**Westinghouse Letter LTR-SGMP-09-109 NP-Attachment, "Response to NRC
Request for Additional Information on H*; RAI #4; Model F and Model D5 Steam
Generators" (Non-Proprietary)**

LTR-SGMP-09-109 NP-Attachment

**Response to
NRC Request for Additional Information on H*; RAI #4;
Model F and Model D5 Steam Generators**

August 25, 2009

Figure RA14-2
Unit Cell Model and Loading Sequence

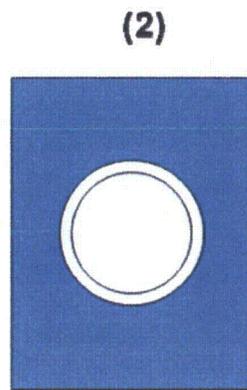
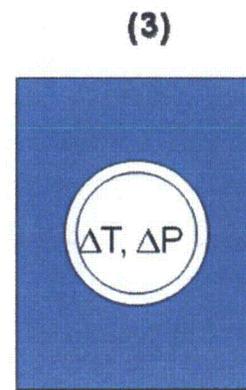
4. *Provide the calculation basis for the upper and lower curves provided in Figure RAI 4-2. (See Section 2.1)*
5. *Resolve the apparent inconsistency between Item 4 on page 25 and the statement below Figure RAI4-1 regarding how the model in Figure RAI4-1 is loaded. (See Section 1.2)*

The "Unit Cell" model is extensively discussed in Section 6.2.5 of the H* WCAPs (References 8 and 9). The specific goal of this model was to determine if tube to tube contact would remain when the tubesheet is deformed due to operating loads. An equivalent tubesheet cell is modeled, that is, a tubesheet bore with surrounding tubesheet material, and a tube in the tubesheet bore (see Figure 6-48 of the H* WCAPs). For the primary purpose of this model – to study if tube-to-tubesheet contact is present during the limiting tubesheet deformations – the model was initialized by simulating the tube expansion process. The expansion process was conservatively simulated by applying a low value of expansion pressure []^{a,c,e} inside the tube, resulting in initial tube to tubesheet contact, and then removing the tube expansion internal pressure. The calculated dilation of the tubesheet bore due to the simulation of the tube expansion is []^{a,c,e} inch for all models of SG considered.

As discussed in Section 6.2.5 of the H* WCAP reports, the operating pressure loads, were applied to the initialized model in a sequential manner, and the resulting contact pressures were calculated when a range of displacements (termed "E-bar") were applied as boundary conditions to the model. Figure RAI4-2 shows the updated sequential loading (includes application of thermal loads) of the model and relates it to the steps discussed in Section 6.2.5 and Tables 6-18 and 6-19 of the H* WCAPs. The "E-bar" values shown as the displacement inputs on Tables 6-18 and 6-19 in the H* WCAP reports are uni-directional displacements (in inches) that are NOT the same as eccentricity and also not the same as ΔD . (Eccentricity is defined as the difference between the maximum and minimum diameters of a bore divided by the nominal diameter of the bore. The units of eccentricity are inch/inch.) The displacement inputs applied to the unit cell model are assumed values that based on prior analyses that envelope the expected tubesheet displacement for all of the applicable operating conditions. It is important to note that the unit cell model as described in Section 6.2.5 of the H* WCAP reports utilizes boundary conditions chosen to minimize the tube-to-tubesheet contact pressures for the applied relative displacements.
